**CITY OF IOWA COLONY**  
**NOTICE OF PUBLIC HEARINGS ON JULY 6 AND 19, 2021,**  
**ON UNIFIED DEVELOPMENT CODE AND ZONING ORDINANCE**

## IOWA COLONY PLANNING AND ZONING COMMISSION MINUTES OF JULY 6, 2021

The City of Iowa Colony staff have received a proposed amendment to the current approved Plan of Development for Sterling Lakes at Iowa Colony/Sierra Vista on July 7, 2021. Documents attached to this LOR include: General Development Plan 11-20-2015; General Development Plan dated 05-01-2018, revised 01-04-2021; Compare Result 1.pdf; Cover Letter Revised.pdf; and Figure 2\_General Plan -markup.pdf.

FIGURE 2

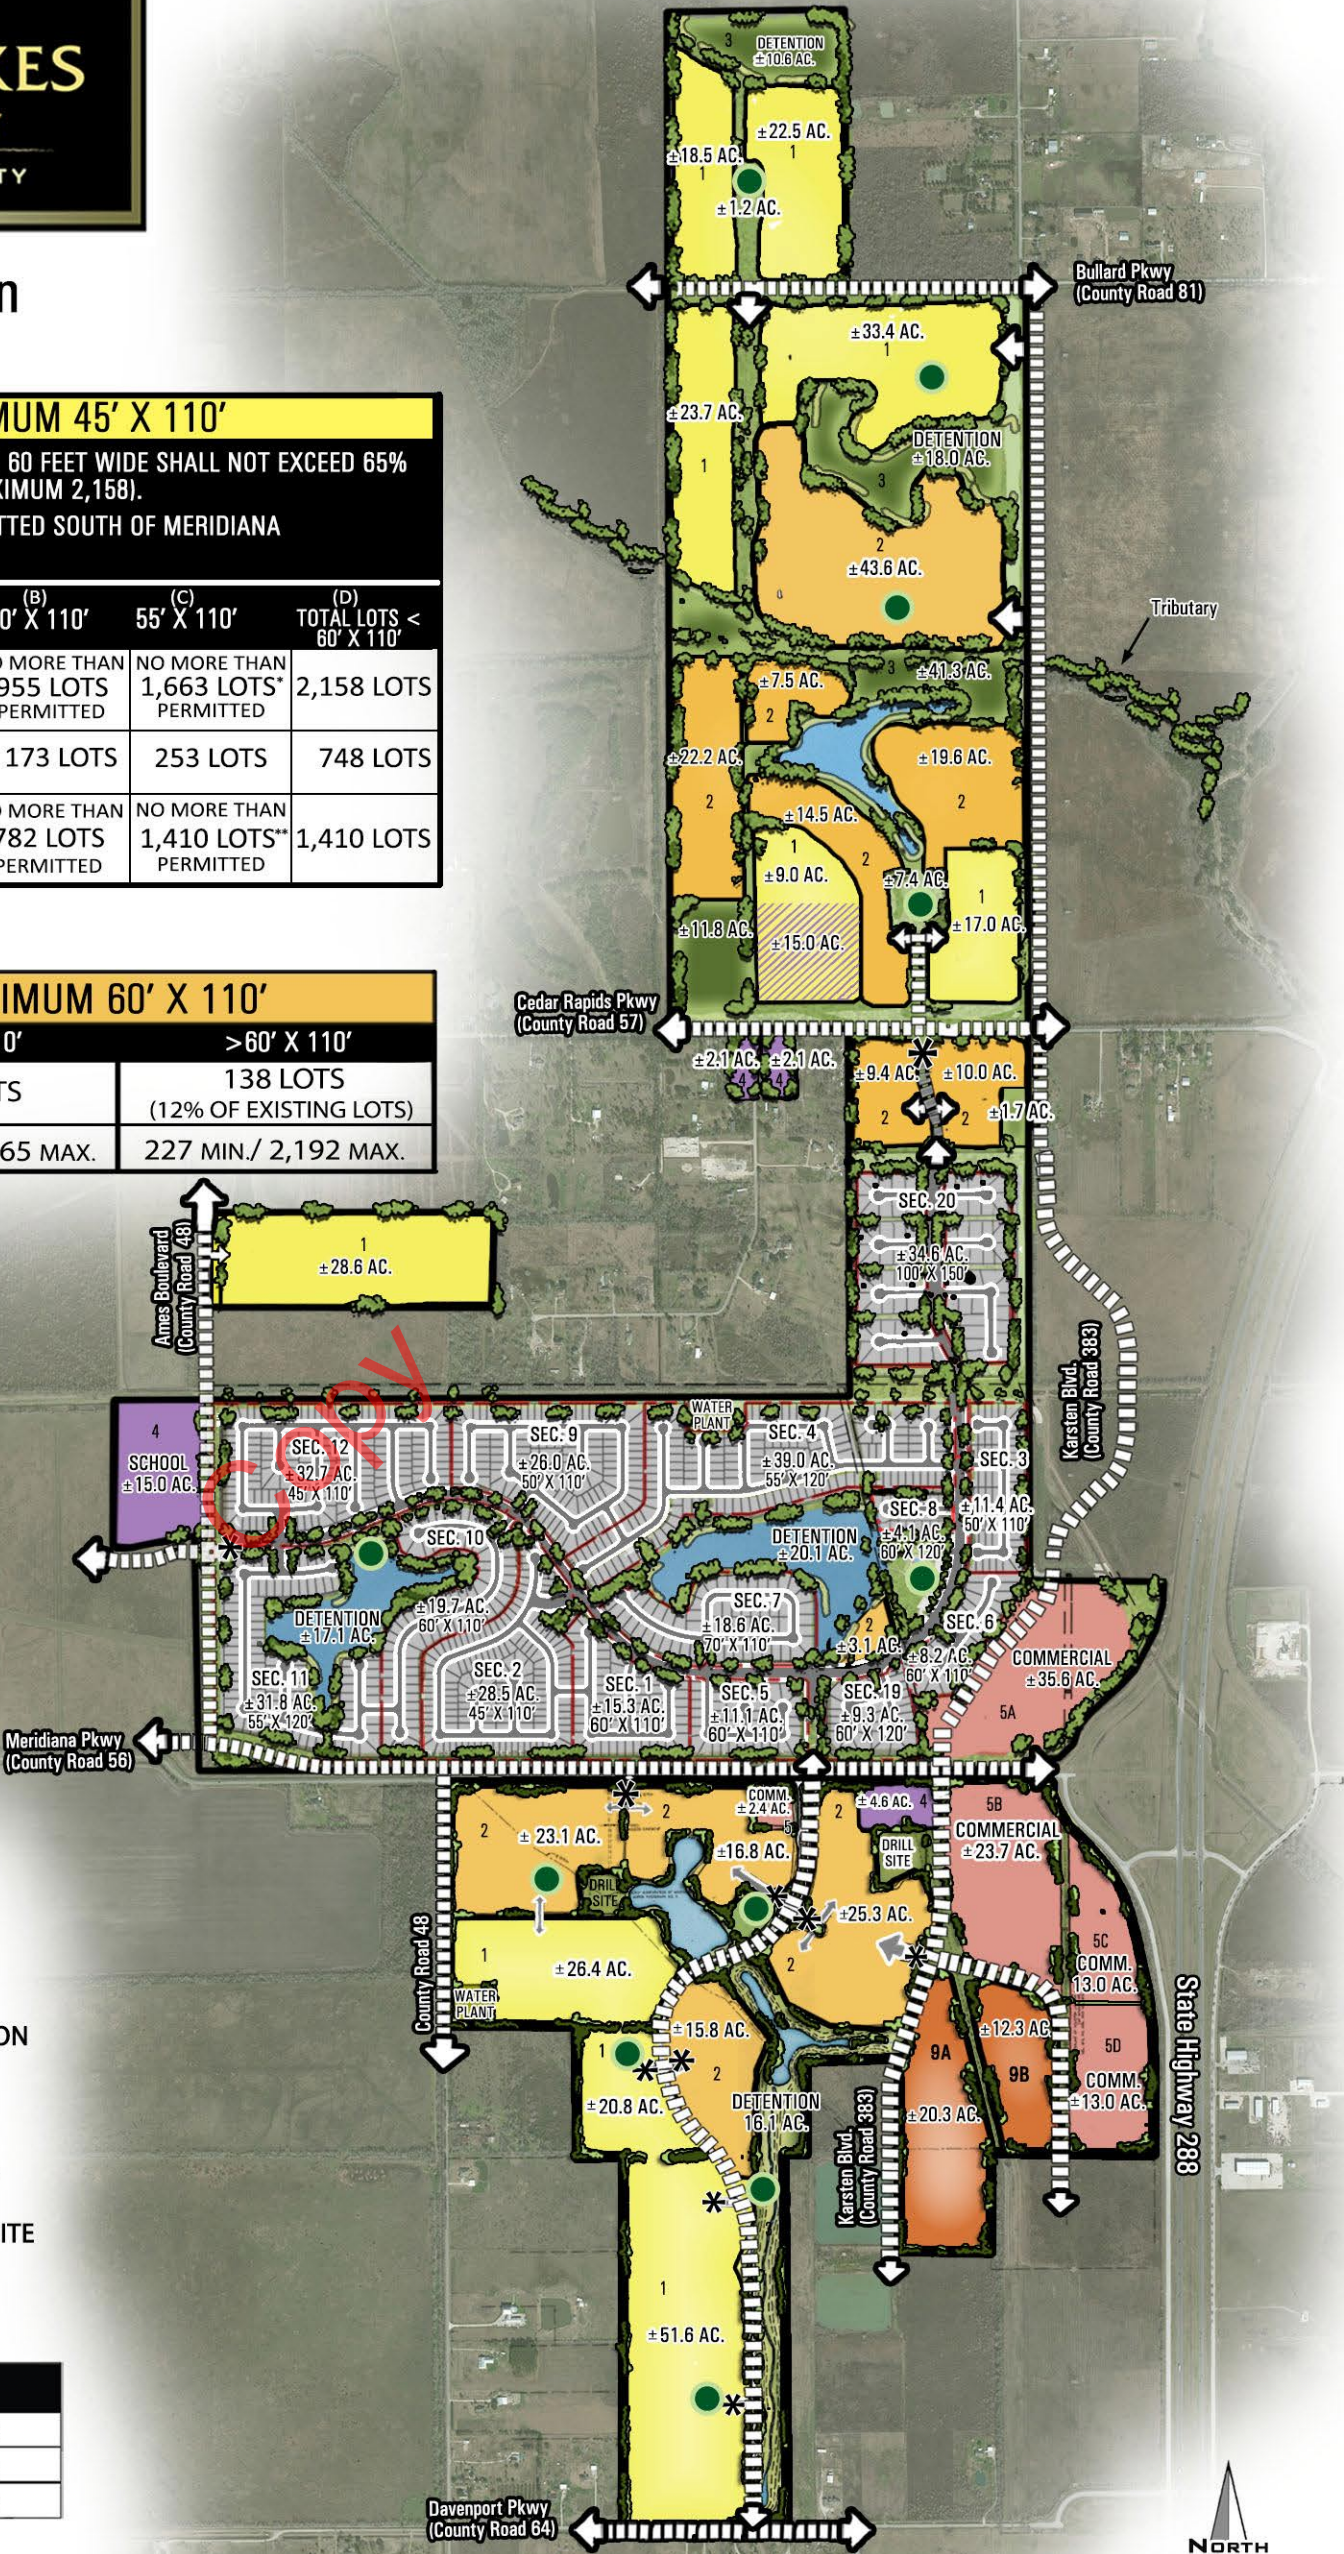
The General Development Plan that first includes both Sterling Lakes and Sierra Vista is dated 11-20-2015 (the 2015 Plan). Figure 2 General Development Plan dated 05-01-2018 (Amendment Number 1), (the 2018 Plan) indicates the approved Plan of Development for the Sterling Lakes/Sierra Vista development prior to the latest round of proposed amendments with the exception of the tract along the south side of Meridiana Parkway and the east side of Sierra Vista Boulevard that was originally approved as single family residential. The 2018 Plan indicated that tract as commercial in color but as number "2" as residential land use. This discrepancy has held approval of a development plat for this tract (the Day Care Center) due to the conflict of land use approval. The 2018 Plan Amendment Number 1 was approved only to modify the alignment of Karsten Boulevard and related adjacent tract land use. The proposed Amendment Number 3 has been submitted correct this issue (shown as 2.9 acre, commercial, number "5"), among other proposed modifications, and clarify the intent for this tract to be commercial, not single family residential. Amendment Number 2, the latest amendment, as recently approved by City Council, only modifies the Sterling Lakes North area of the overall development north of Cedar Rapids Parkway. Amendment Number 3 has now been proposed as partially indicated in Figure 2\_General Plan -markup. Additionally, the proposed Amendment Number 3 General Plan indicates a change in land use for the area south of Meridiana Parkway and west of Crystal View Drive, a change in land use for the area south of Meridiana Parkway and east of Crystal View Drive including a 2.4 acre commercial tract correctly shown on the 2015 Plan and the 2018 Plan and now proposed to be a part of the indicated 4.1 acre commercial tract on the west side of Sierra Vista Boulevard. Discussion with Stan Winter, the planning consultant for Land Tejas indicates the applicant wishes to remove from consideration the indicated change of land use for a tract labeled 9A west of Karsten Boulevard at the southeast corner of the Sierra Vista development and to remove from consideration the proposed change in the language of the Plan of Development document regarding a Townhouse land use applicable to tract 9A.

FIGURE 9

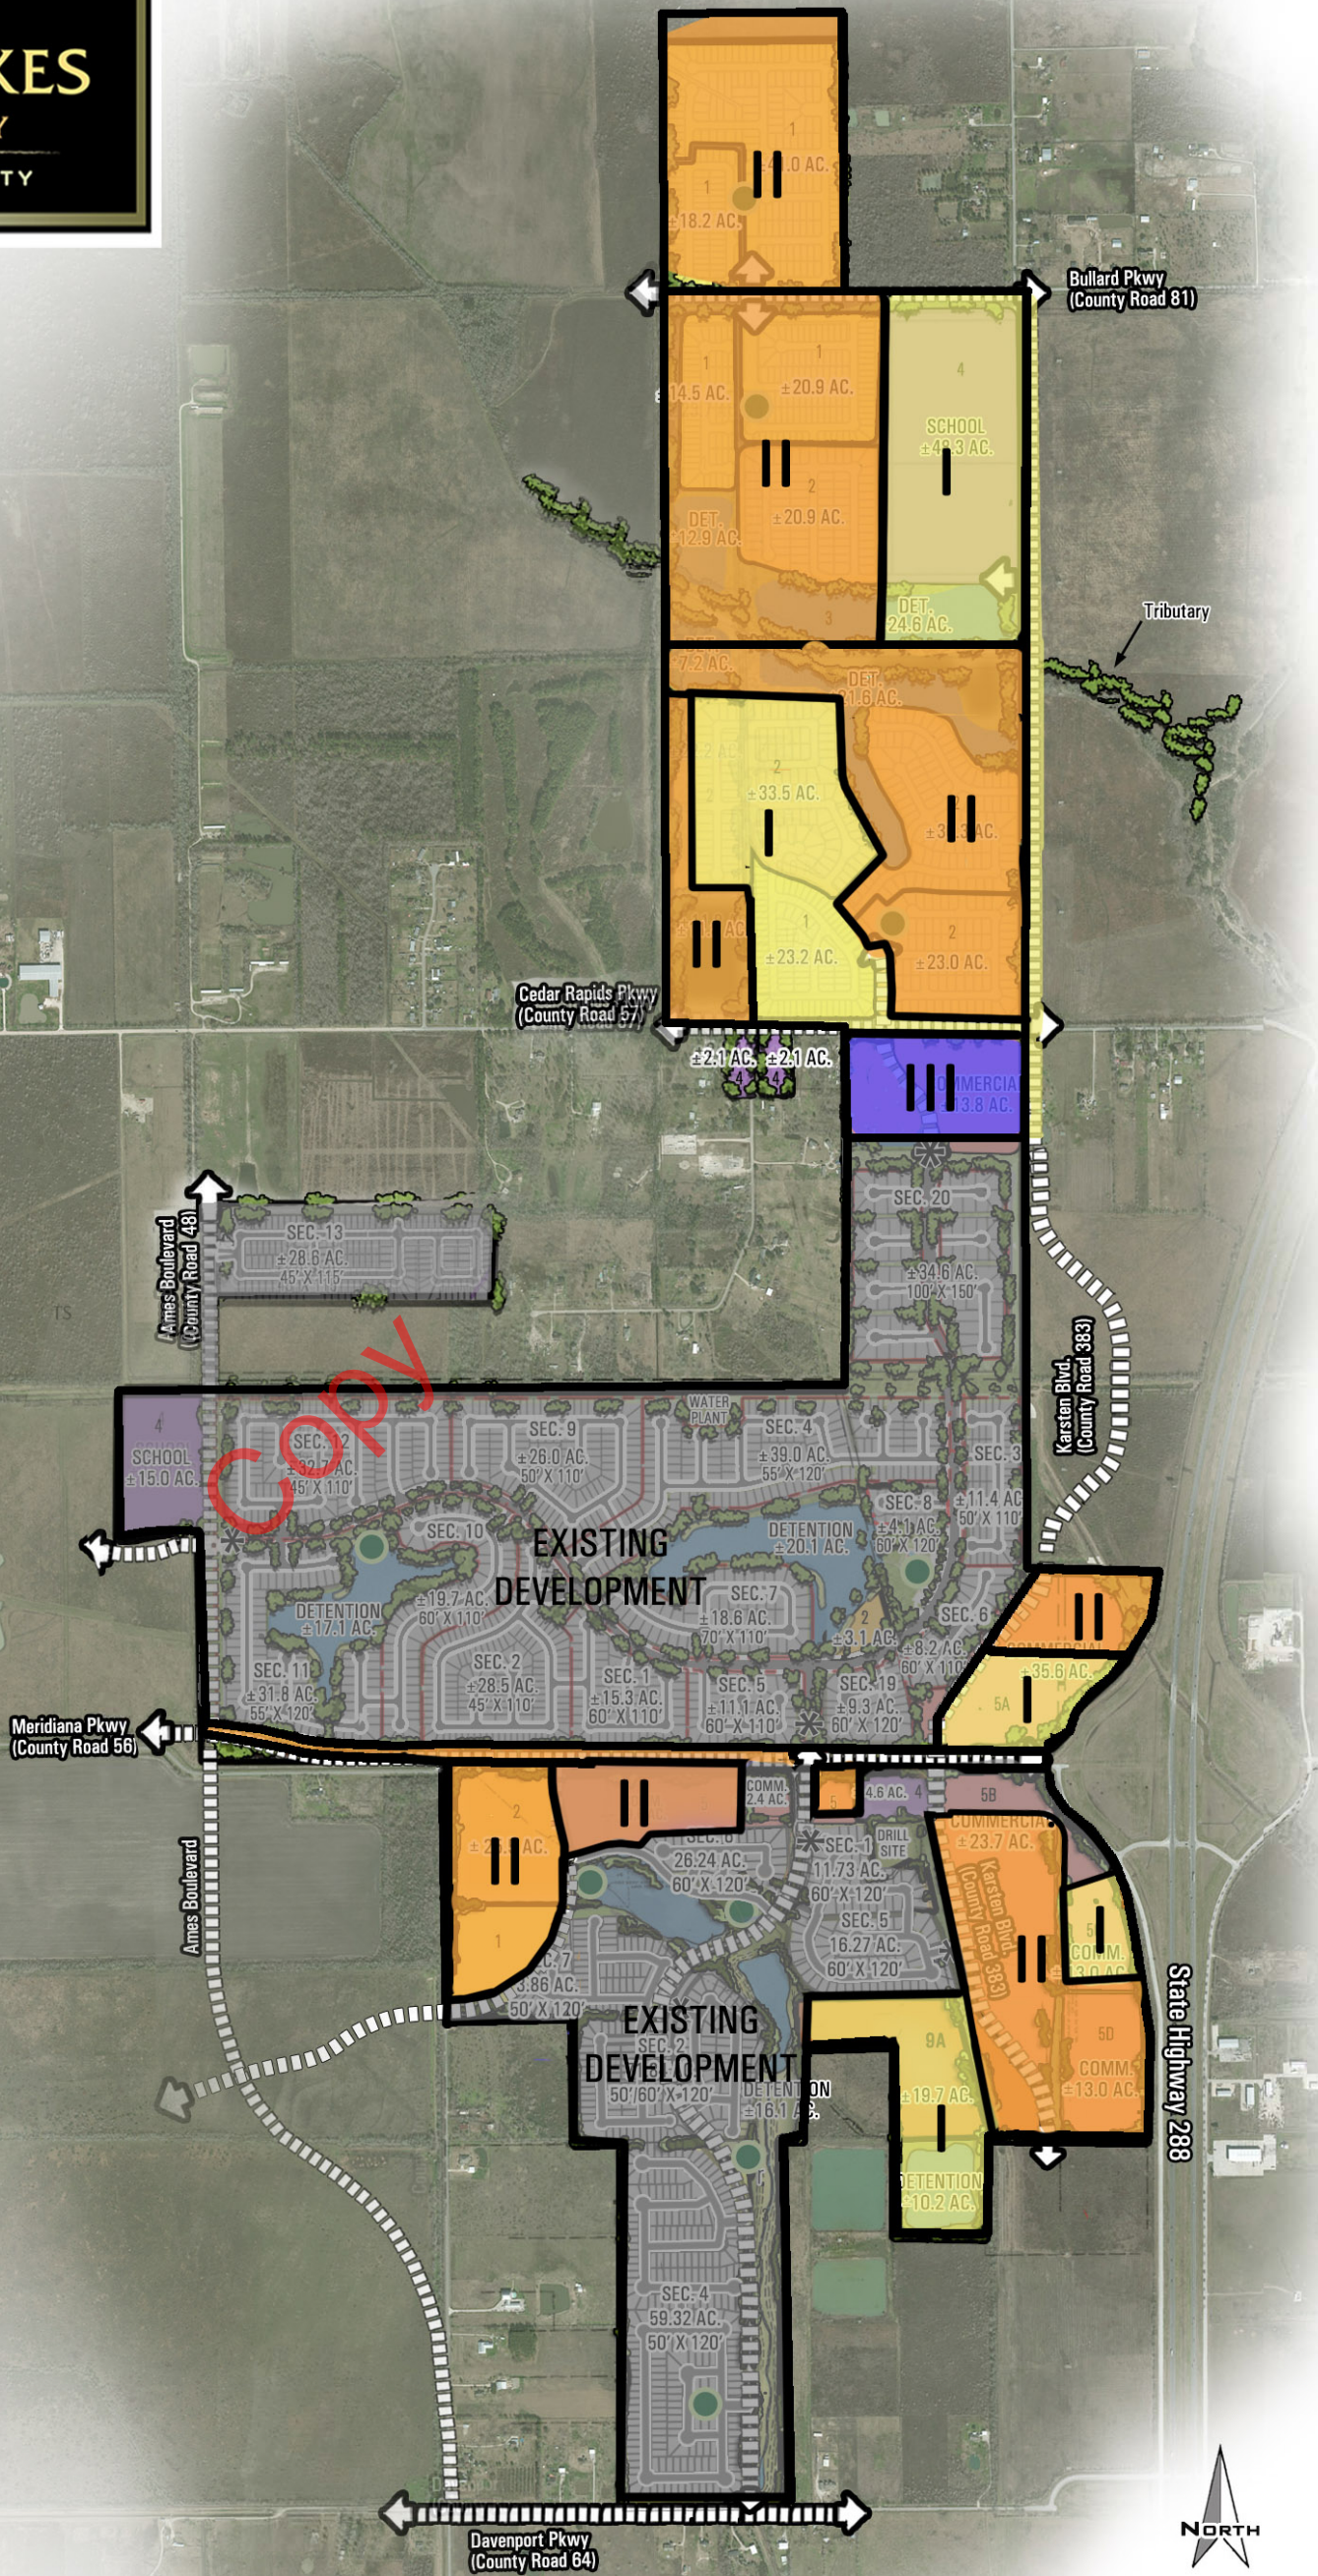
- Figure 1: *Boundary Exhibit - no change*  
Figure 1a: *Jurisdiction Map - no change*  
Figure 2: *General Development Plan –*  
*The map was revised to show the extension of “Commercial” uses along*  
*the south side of Meridiana Blvd..*  
Figure 3: *Landscape and Open Space Plan – no change*  
Figure 4: *Thoroughfare Exhibit – no change*  
Figure 5: *Street cross section for Spine Road, (divided)- no change*  
Figure 6: *Street cross section for Spine Road, (undivided) – no change*  
Figure 7: *Pedestrian cross section and detail – no change*  
Figure 8: *Sterling Lakes North General Plan- no change*  
Figure 9: *Phasing Plan of Development – no change*  
Figure 10: *to be added before CC meeting – Sterling Lakes North Road*  
*Construction Sequence.*
